Access Compliance Report

Public Rights-of-Way

Intersection ID: 2731	Main Street: TANAGER_LN	Cross Street: VIREO_CT	Location: SW
ADA ID: C3D21AA2F56C	Ramp Type: Perp	Initial Pass/Fail: Fail	Overall Compliance: No
Severity Score: 10			
Codes/Mitigation Info/Possible Solution		Field Measurements/Component Compliance

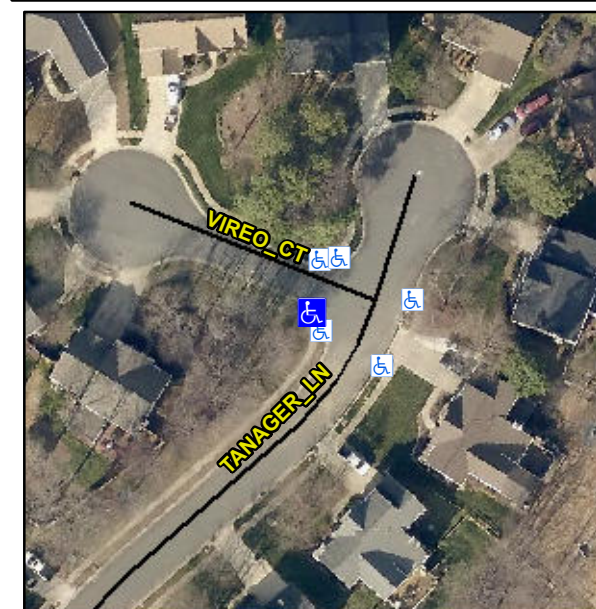
Remove & Replace Entire Ramp.

R304.5.1, R304.5.3

Compliance	Description	Data	Compliance	Description	Data
N/A	Ramp Length (in)	48.0	Yes	Ramp Slope (%)	5.3
No	Ramp Width (in)	41.0	No	Ramp XSlope (%)	4.3
N/A	Flare Type LT	N/A	N/A	Flare Type RT	N/A
N/A	Flare Slope LT (%)	N/A	N/A	Flare Slope RT (%)	N/A
N/A	Flare Traversable LT?	N/A	N/A	Flare Traversable RT?	N/A
N/A	Landing Length (in)	N/A	N/A	DWS Provided?	N/A
N/A	Landing Width (in)	N/A	N/A	DWS Contrast?	N/A
N/A	Landing Slope (%)	N/A	N/A	DWS Length (in)	N/A
N/A	Landing X Slope (%)	N/A	N/A	DWS Full Width?	N/A
N/A	Landing Curb? (Y/N)	N/A	N/A	DWS Offset (in)	N/A
N/A	Shared Landing?	N/A			
N/A	Gutter Ponding?	N/A	N/A	Gutter Slope (%)	N/A
N/A	Gutter Lip Ht (in)	N/A	N/A	Gutter X Slope (%)	N/A
N/A	Painted X Walk1?	No	N/A	Painted X Walk2?	N/A
	X Walk 1 Direction	To NE		X Walk 2 Direction	N/A
N/A	X Walk 1 Width (in)	N/A	N/A	X Walk 2 Width (in)	N/A
	X Walk 1 Slope (%)	2.7		X Walk 2 Slope (%)	N/A
	X Walk 1 X Slope (%)	5.0		X Walk 2 X Slope (%)	N/A
